Access Compliance Report

Public Rights-of-Way

(Curb Ramps)

Intersection ID: 7231	Main Street: BELMEADE_DR	Cross Street: AMOS_HOARD_RD	Location: SW
ADA ID: 9374EF8FCDB1	Ramp Type: Perp	Initial Pass/Fail: Fail	Overall Compliance: No
Severity Score: 21.25			
Codes/Mitigation Info/Possible Solution		Field Measurements/Component Compliance

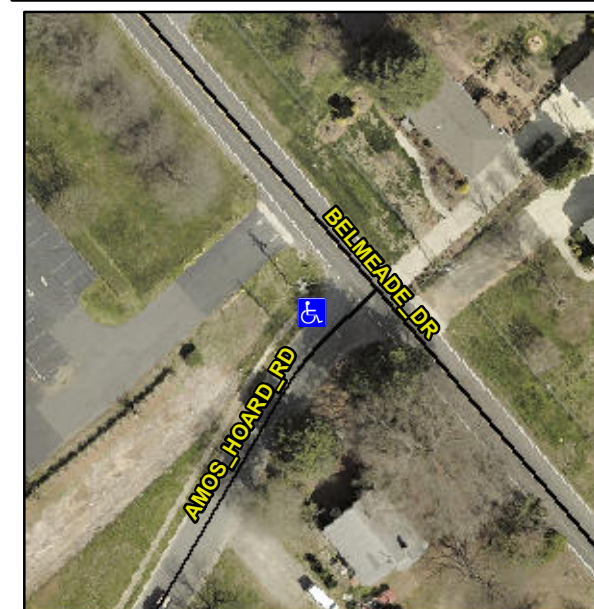
R304.5.1, R304.5.3

Compliance	Description	Data	Compliance	Description	Data
N/A	Ramp Length (in)	47.0	Yes	Ramp Slope (%)	5.4
No	Ramp Width (in)	46.0	No	Ramp XSlope (%)	5.7
N/A	Flare Type LT	N/A	N/A	Flare Type RT	N/A
N/A	Flare Slope LT (%)	N/A	N/A	Flare Slope RT (%)	N/A
N/A	Flare Traversable LT?	N/A	N/A	Flare Traversable RT?	N/A
N/A	Landing Length (in)	N/A	N/A	DWS Provided?	N/A
N/A	Landing Width (in)	N/A	N/A	DWS Contrast?	N/A
N/A	Landing Slope (%)	N/A	N/A	DWS Length (in)	N/A
N/A	Landing X Slope (%)	N/A	N/A	DWS Full Width?	N/A
N/A	Landing Curb? (Y/N)	N/A	N/A	DWS Offset (in)	N/A
N/A	Shared Landing?	N/A			
N/A	Gutter Ponding?	N/A	N/A	Gutter Slope (%)	N/A
N/A	Gutter Lip Ht (in)	N/A	N/A	Gutter X Slope (%)	N/A
N/A	Painted X Walk1?	No	N/A	Painted X Walk2?	N/A
	X Walk 1 Direction	To S		X Walk 2 Direction	N/A
N/A	X Walk 1 Width (in)	N/A	N/A	X Walk 2 Width (in)	N/A
	X Walk 1 Slope (%)	3.6		X Walk 2 Slope (%)	N/A
	X Walk 1 X Slope (%)	6.6		X Walk 2 X Slope (%)	N/A

Remove & Replace Entire Ramp.
